WOODLAND PARK APARTMENTS

3670 WOODLAND PARK AVE NORTH
SEATTLE, WA 98103

DESIGN REVIEW

11.11.2025

EDG 2 FEEDBACK AND RESPONSE:

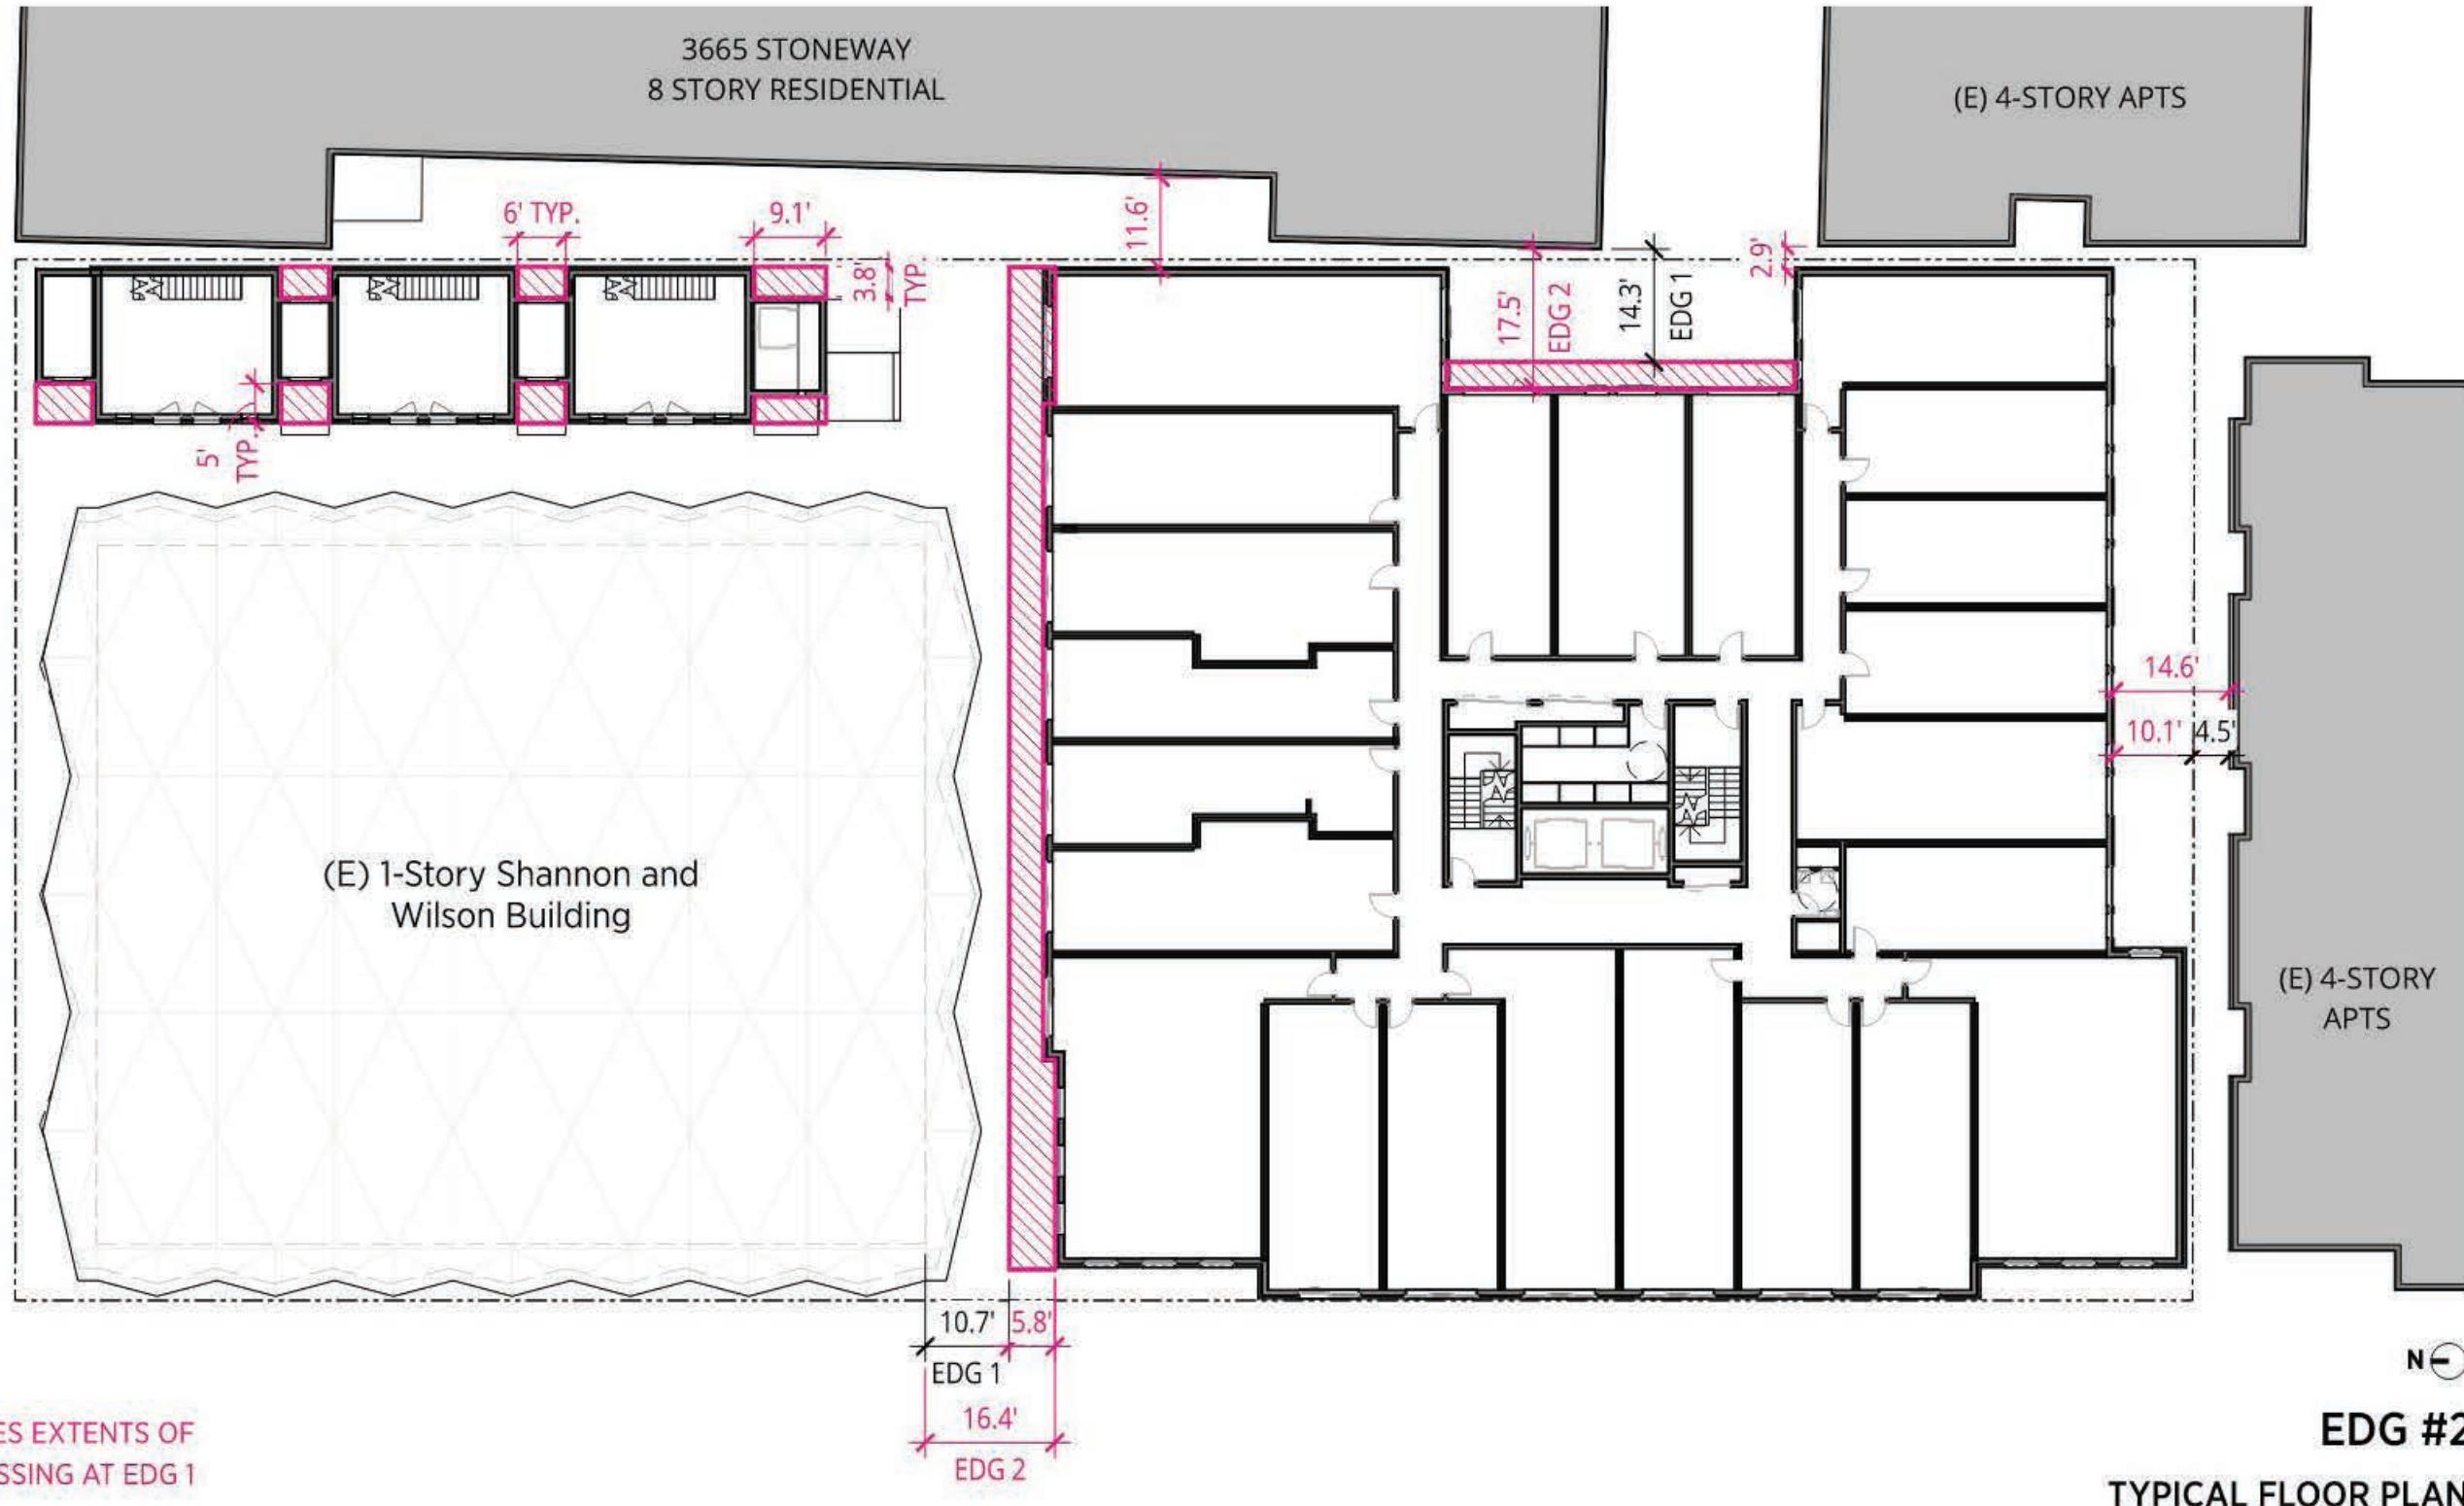
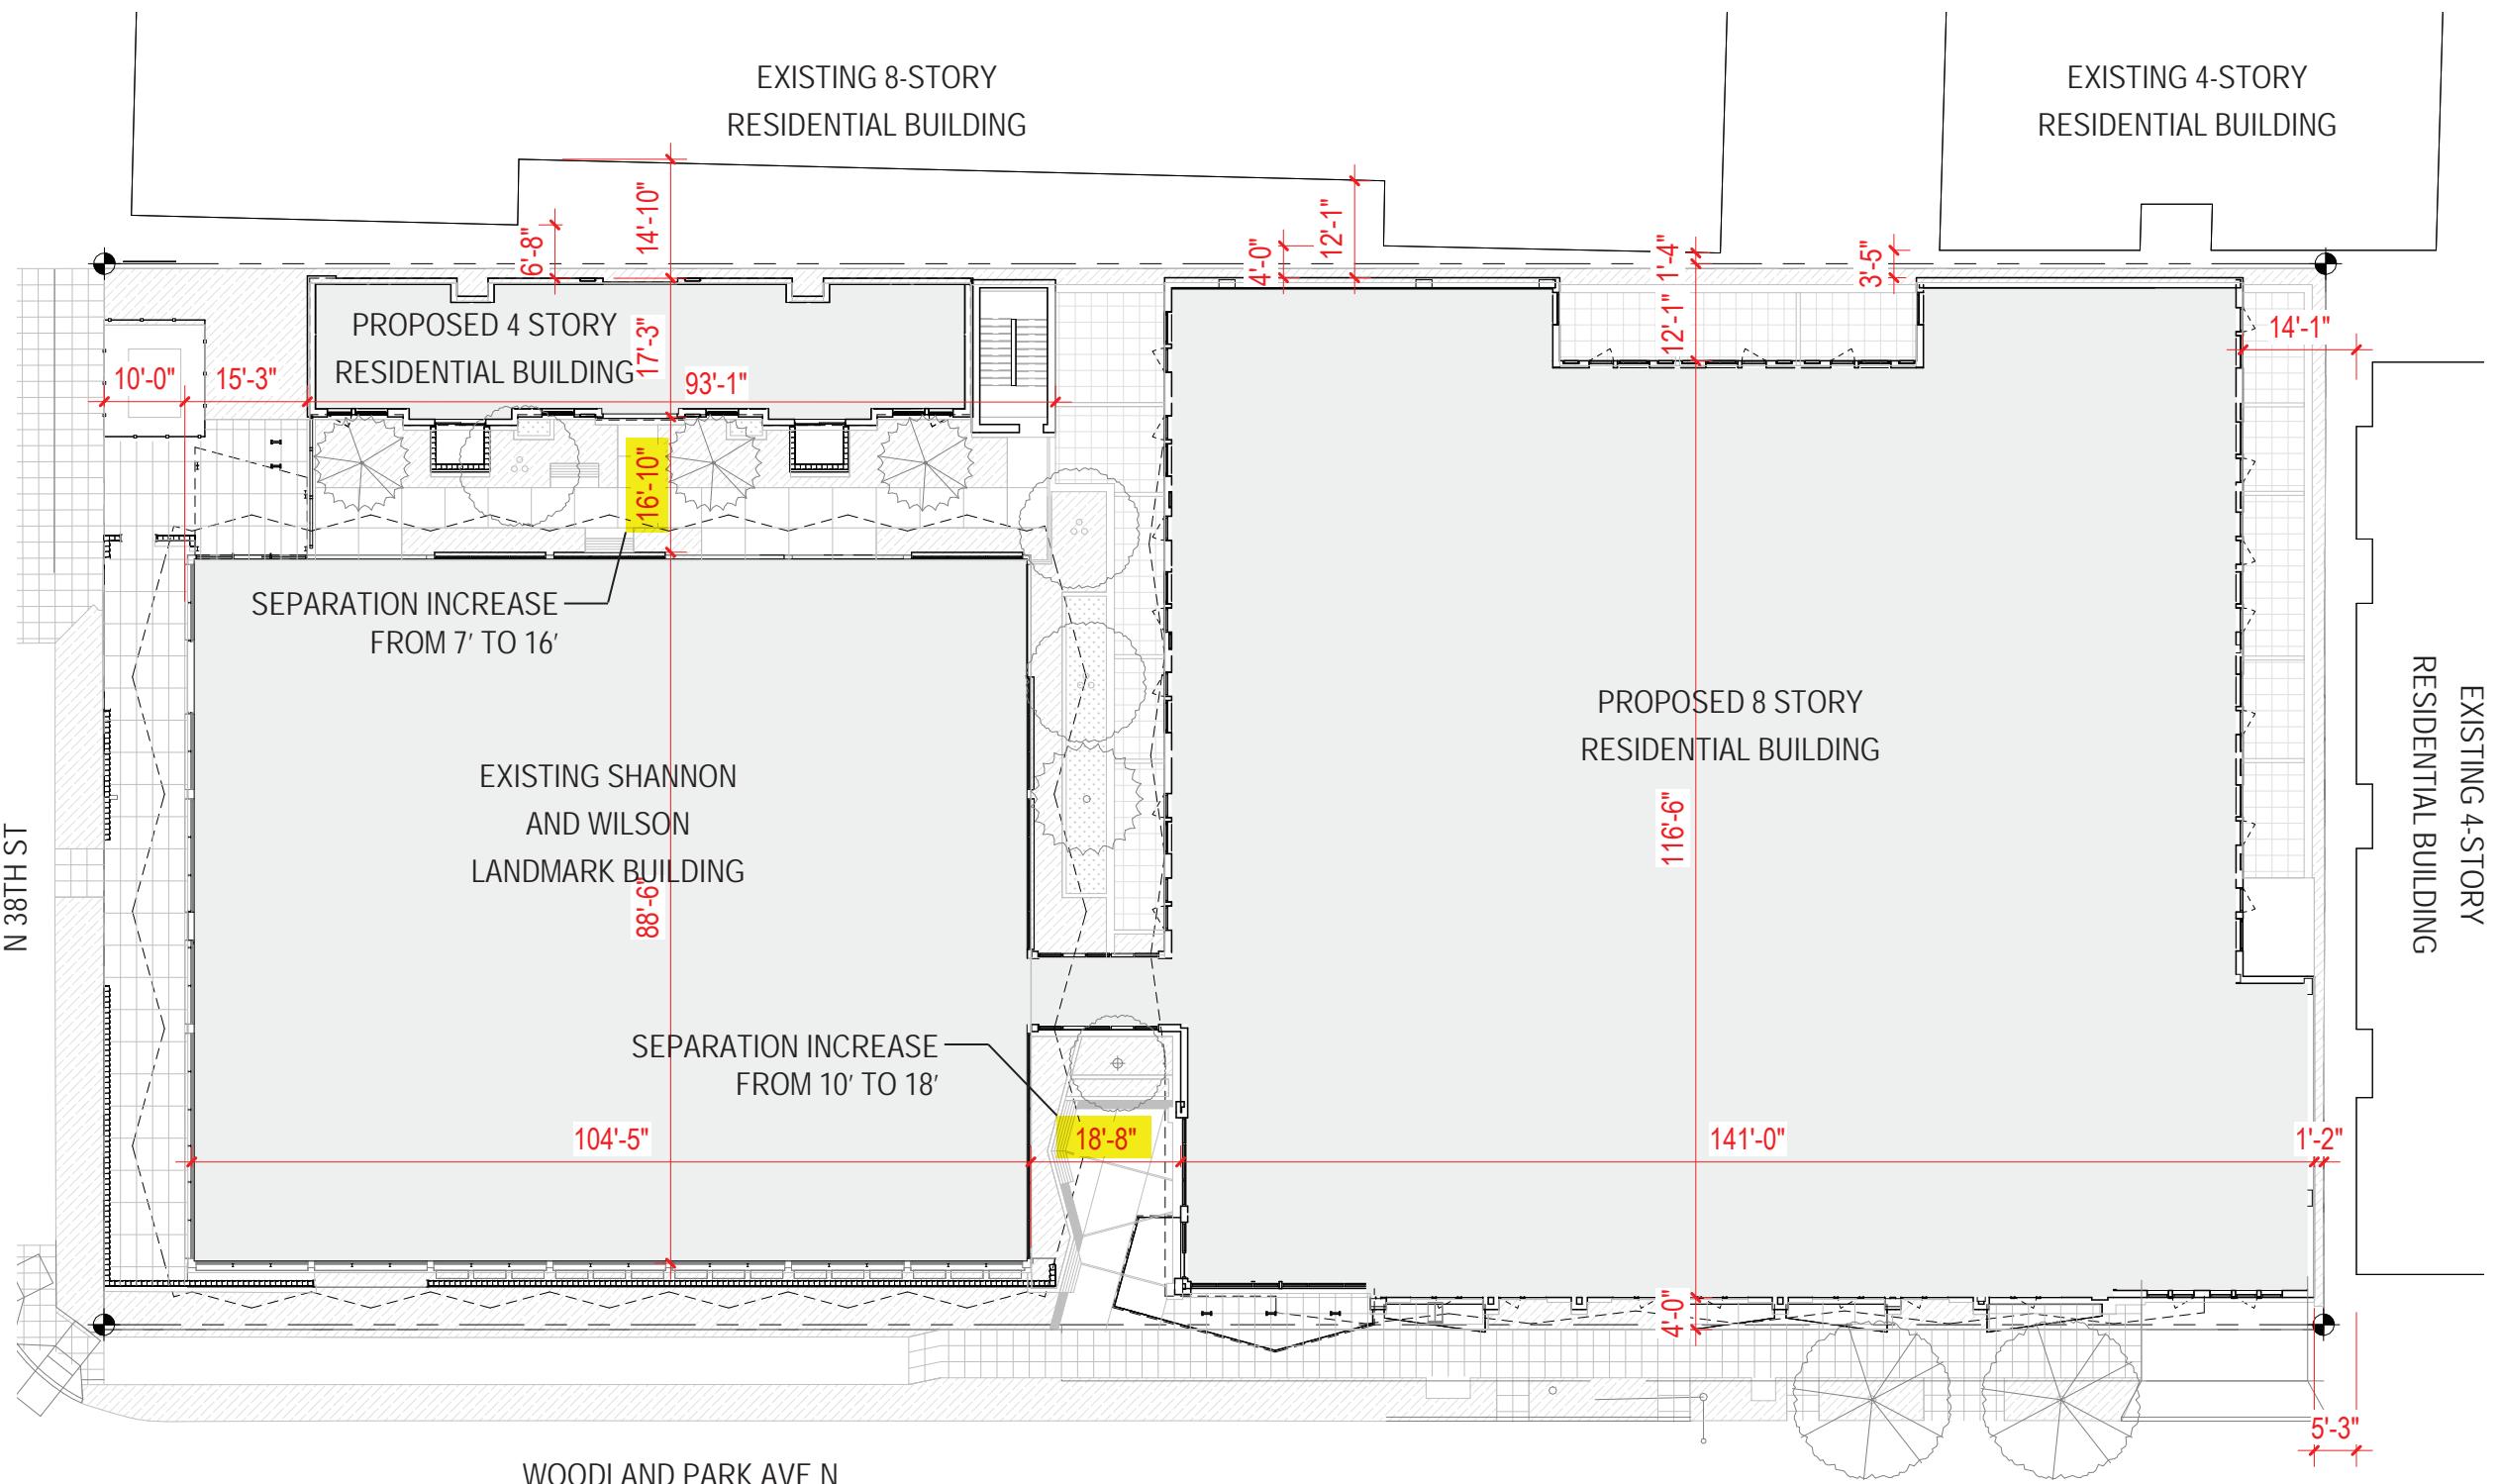
- **Increased setbacks from Landmark Structure** - Further increased setbacks in areas with adjacent buildings and particularly where adjacent buildings have windows facing the interior property line. The Setbacks from the Landmark building have been increased:
 - **East Setback increased from 7' to 16'-10"**
 - **South Setback increased from 10' to 18'-8"**
- **Additional Green space** - Setbacks have been provided with green space or landscaped areas to help soften the space
- **Increased Modulation** - Additional separation and modulation provided on all facades
- **Breathing Room** - Additional space provided around the historic landmark Shannon Wilson building to allow it to "breathe". This additional space was provided in direct response to EDG feedback. (CS2, CS3, PL3-A, DC2, PL3)

- **Departure Requested** - Massing of the proposed residential buildings is intentionally pulled back from existing landmark building and street frontage to reduce visual dominance and allow historic building to remain a focal point on site. See page 76 for departure information

- **Increased Landscaping** - Moving existing surface parking underground and replacing it with generous landscaped buffers between the new buildings and the landmark to create a soft transition and enhance the setting of the historic structure.

- **Layered Planes** - Architectural design elements and material patterns of new construction subtly reference the landmark building, bringing visual harmony and reinforcing the landmark's prominence through material use and massing.

- **Balance** - By using a lower 4-story building adjacent to the Shannon & Wilson building, the current contrast of scale between the newly constructed neighboring 8-story structure and the Shannon & Wilson building is minimized and helps the new development act as a respectful backdrop rather than a competing presence.

- **Residential Entry B** - Using a recessed entry and small plaza to help provide connection to the street while providing an amenity and separation to the landmark (PL3-A, DC3, PL3)

WOODLAND PARK STREETSCAPE

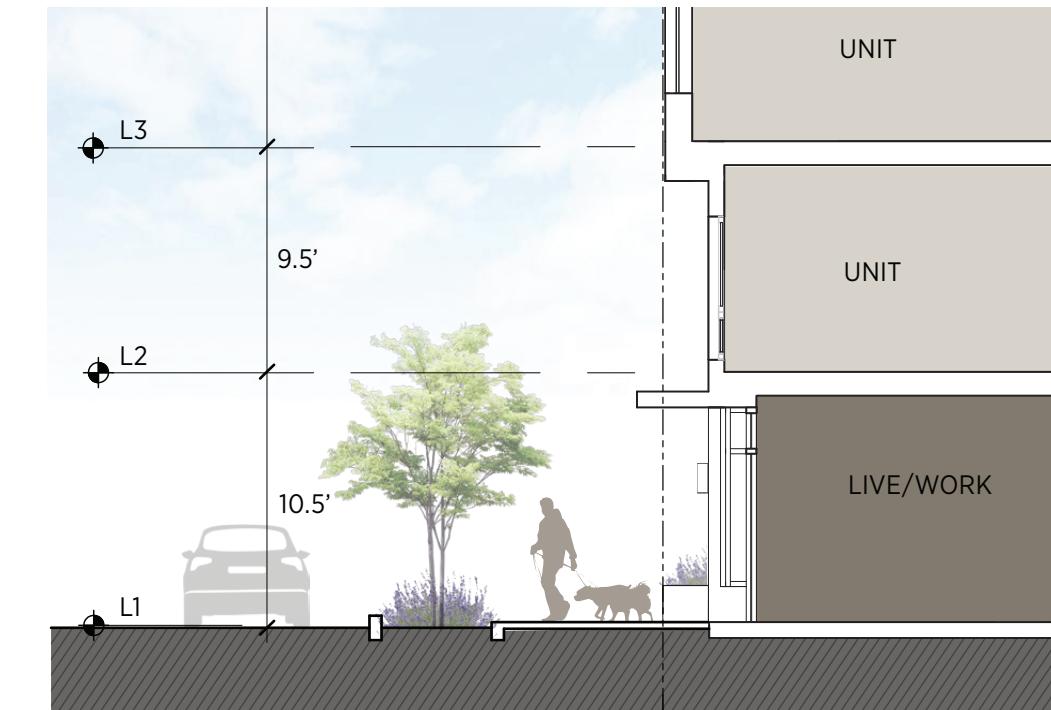
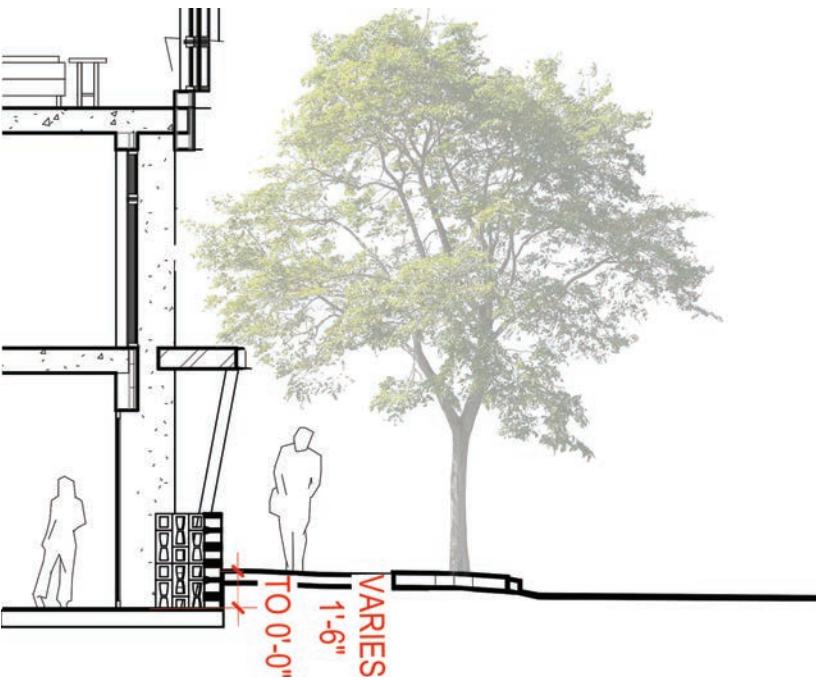
Response to Board Guidance
STREET LEVEL

- Live/work units have been replaced with residential units at grade (commercial/retail is not required on this site and wouldn't fit with the residential character of this section of Woodland Park Ave N.)

- Residential unit entries are defined with individual canopies, protected stoop spaces, screened with breezeblock pony walls taking design cues from the landmark structure's screen walls.

- An additional canopy is provided at the lobby space and mini-plaza. All canopies' composition relates to the Shannon Wilson folded concrete roof structure.

- Material palette has been refined with concrete pilasters and vertical metal box-rib panels. This helps emphasize the podium base, which strengthens the tripartite organization to the building.

- The composition of this facade has been refined, introducing a more regimented rhythm instead of one flat plane, which relates to the Shannon Wilson building's regimented facade.

- The garage entry has been pushed back to allow for a safer pedestrian experience along Woodland Park Avenue.
- A departure is requested for the finish floor elevation of the at-grade residential units to allow for a higher degree of connection between the residential units and the streetscape. Given the neighborhood feel of Woodland Park Avenue, this design approach is appropriate for this use in this location.
